King County
Department of Natural Resources
Director's Office
King Street Center
201 S. Jackson St., Suite 700
Seattle, WA 98104 - 3855

February 22, 2001

Ann Kenny
Senior Permit Specialist
Washington State Department of Ecology
Northwest Regional Office
3190 - 160th Avenue SE
Bellevue, WA 98008-5452

The December 2000 Comprehensive Stormwater Management Plan (SMP) was reviewed for consistency with technical provisions of the 1998 King County Surface Water Design Manual (KCSWDM). The enclosures to this letter detail findings regarding compliance. The review has found that in most areas the SMP includes stormwater mitigations consistent with the standards set forth in the KCSWDM. In a few areas issues have been raised which would need to be addressed prior to King County Department of Natural Resources (KCDNR) being able to issue a statement of concurrence. It is recommended that KCDNR review staff work directly with technical staff from the Washington State Department of Ecology (Ecology) and the Port of Seattle (Port) to address these issues, and related issues raised through recent public comment process, through specific update replacements to the December SMP.

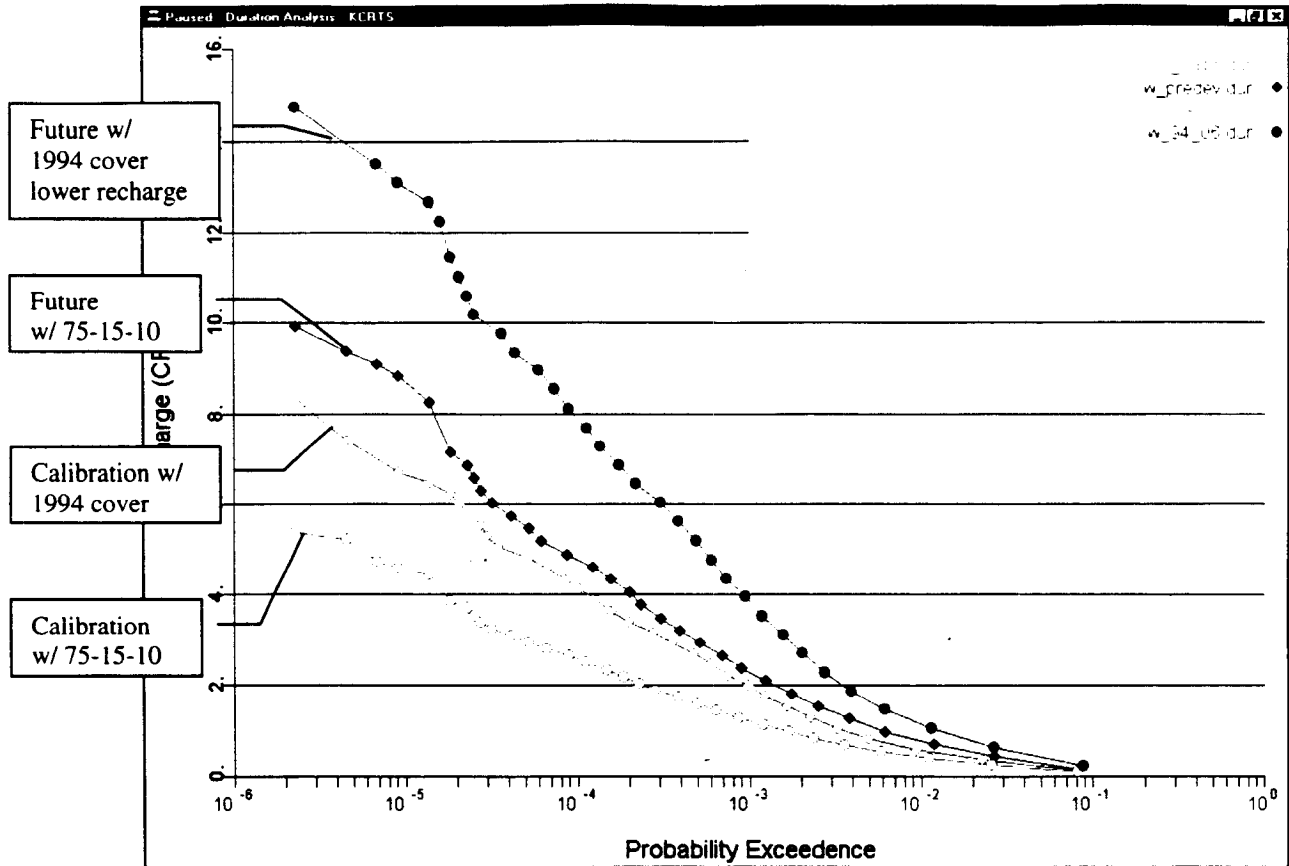
14. Table 4-5 - The first 7 stormwater storage facilities are included in the HSPF models. The last 4 facilities are not. It is not known whether the areas served by these facilities will be retrofitted to the same target flow regime as the rest of the project site. The assumption is that they are not being retrofitted. As no future development activity has been identified for these areas, KCSWDM flow

control requirements would not be applicable. However, it is unclear how these projects relate to the SMP approach of retrofitting the entire project site to the target flow regime.

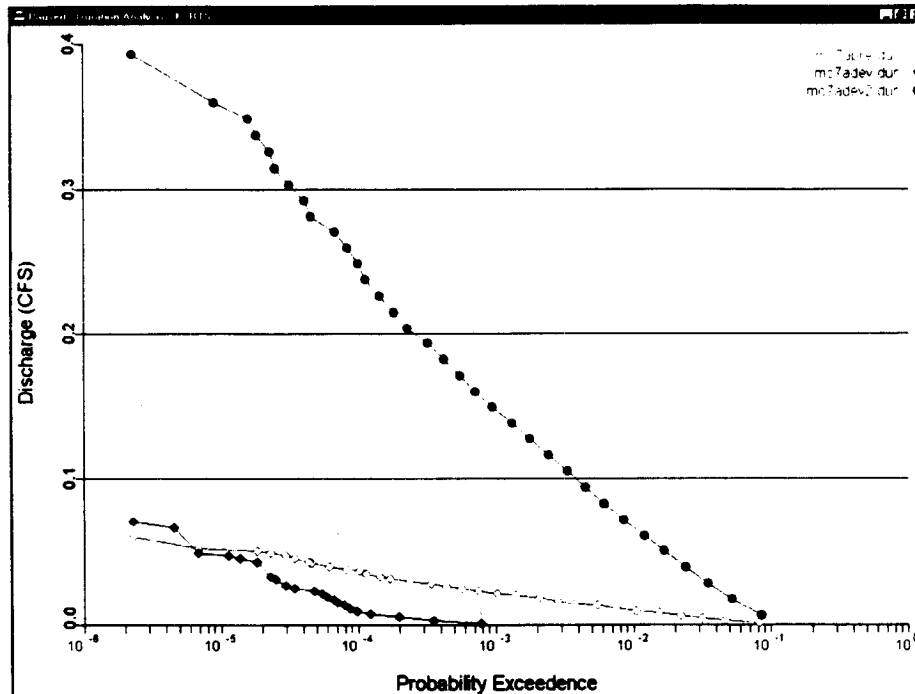
1. The modeled postdeveloped landcover assumptions are not consistent with the plan sheet entitled Proposed Impermeable Surface Area which shows 1.3 acres of total impervious coverage. When modeled, the postdeveloped flow durations are less than predeveloped flows over a majority of the flow range (compare the two curves with diamond shaped symbols. Note: solid symbol is post developed runoff without flow control).
2. No provision for the offsite flows which are being directed through the flow control pond. These flows may exceed the threshold requiring the offsite flows to bypass the flow control pond.

3. From the grading plan it appears that the pond side-slopes are steeper than 3:1, which would require fencing per KCSWDM. The proposed fencing does not extend around the proposed pond.
4. From the below graph it is apparent how significant the difference in post-developed landcover assumptions are (compare the two curves with solid symbols).
